DSA Comments on CEC Draft Report Qualifying Capacity of Supply-Side DR

Comments on CEC Draft Report Qualifying Capacity of Supply-Side DR

Qualifying Capacity of Supply-Side Demand Response Working Group Draft Report

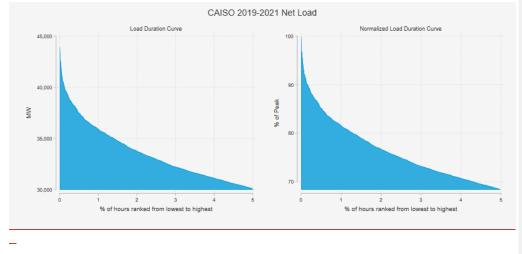
Commented [JB1]: Edited for accuracy. The initial draft made it seem like it is the de facto method, when 2021 was an after the fact test with sample data.

- □ California ISO demand response program adjustments: Starting in the summer 2021, the California ISO implemented baseline adjustments tested baseline methods. through comparison group method changes that relied on matched control groups and changes to the adjustment factors, used in the baseline calculations as permitted under the California ISO tariff. This process allowed a more accurate assessment of demand response load reduction during extreme events. The two baseline improvement tracks instituted for the summer included 1) exploring the use of comparison/control group method and 2) establishing a process and criteria for approved use of load adjustment factors outside of the min/max caps for summer 2021. The method has the potential for improving the accuracy of settlements for weather sensitive resources, if it is widely adopted. The approach relies on smart meter data for non-participants and, as a results, concerns about privacy of data and the ability of third parties to replicate the baselines need to be addressed.
